**ZONING AMENDMENT,**  
**PLANNED UNIT DEVELOPMENT &**  
**SUBDIVISION STAFF REPORT**

**Date: October 4, 2007**

<b><u>NAME</u></b>	Creekline Subdivision, Twelfth Addition
<b><u>SUBDIVISION NAME</u></b>	Creekline Subdivision, Twelfth Addition
<b><u>LOCATION</u></b>	Northeast corner of Higgins Road and Shipyard Road, extending Northwardly 3415'± along the East side of Shipyard Road.
<b><u>CITY COUNCIL DISTRICT</u></b>	District 4
<b><u>PRESENT ZONING</u></b>	B-1, Buffer Business District
<b><u>PROPOSED ZONING</u></b>	B-3, Community Business District
<b><u>AREA OF PROPERTY</u></b>	12 Lots / 7.3± Acres
<b><u>CONTEMPLATED USE</u></b>	<p>Rezoning from B-1, Buffer Business District to B-3, Community Business District, to allow offices with light warehousing, Planned Unit Development Approval to allow reduced building setbacks and increased site coverage and Subdivision of three metes and bounds parcels into twelve lots.</p> <p><b>It should be noted, however, that any use permitted in the proposed district would be allowed at this location if the zoning is changed. Furthermore, the Planning Commission may consider zoning classifications other than that sought by the applicant for this pro

## SITE PLAN

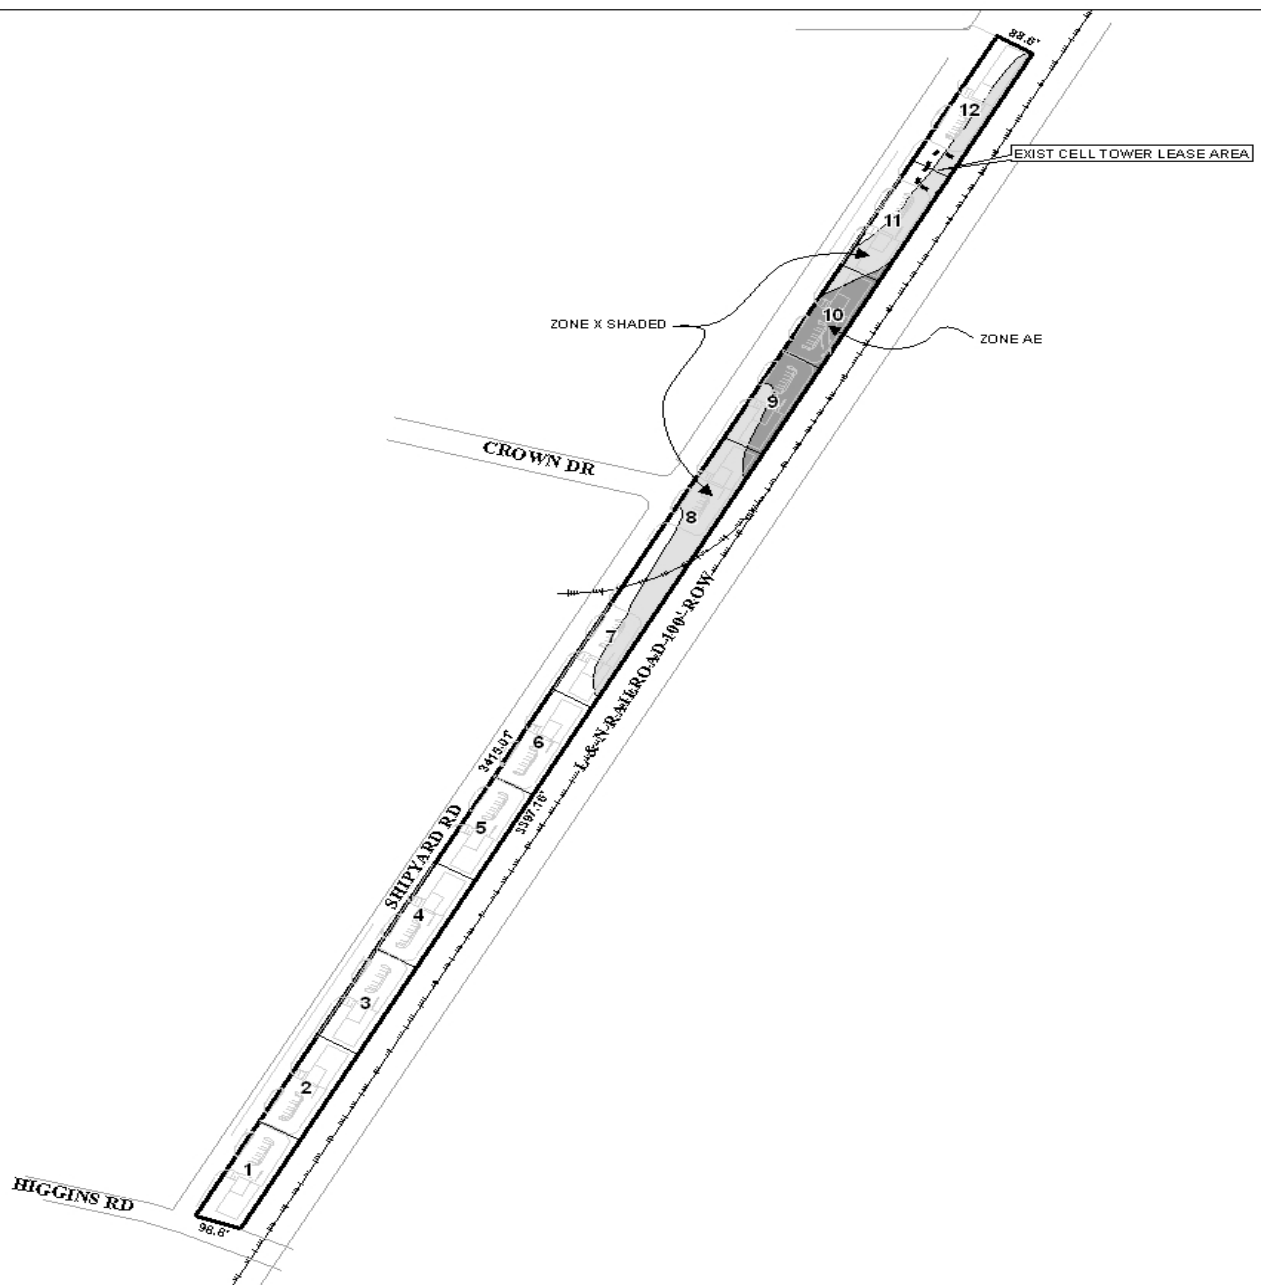
The applicant is proposing a 12-lot commercial subdivision. Lot 10, the smallest with approximately 22,626 square feet and Lot 8, the largest providing approximately 34,926 square feet. As illustrated on the preliminary site plan all lots show a 5,000 square foot office/warehouse with the required parking spaces, landscaping and tree planting requirements. However, the site plan does not illustrate the location of any dumpster or buffering as required.

It should be noted that the applicant is requesting Planned Unit Development approval to allow the reduction of front setback requirements from 25-feet to 15-feet and to increase the site coverage to 50 percent. As illustrated on the preliminary site plan the development does not come close to exceeding the front setback and site coverage limits of the Zoning Ordinance; therefore, because Planned Unit Development (PUD) approval is site specific the request to reduce the front yard setback and increase the site coverage limit is not needed, so the request should be denied.

**Planned Unit Development:** The PUD request is recommended for denial, due to the request is not required.

- 1) illustration of the right-of-way of all road frontages on the Final Plat;
- 2) depiction of the 25' minimum building setback line on all road frontages;
- 3) placement of a note on the final plat stating that each lot is limited to two curb cuts to Shipyard Road, with the size, location, and design of all curb cuts to be approved by Traffic Engineering and conform to AASHTO standards;
- 4) the labeling of each lot with its size in square feet, or placement of a table on the plat with the same information; and
- 5) the provision of a 6-foot high solid wooden fence along the railroad right-of-way.
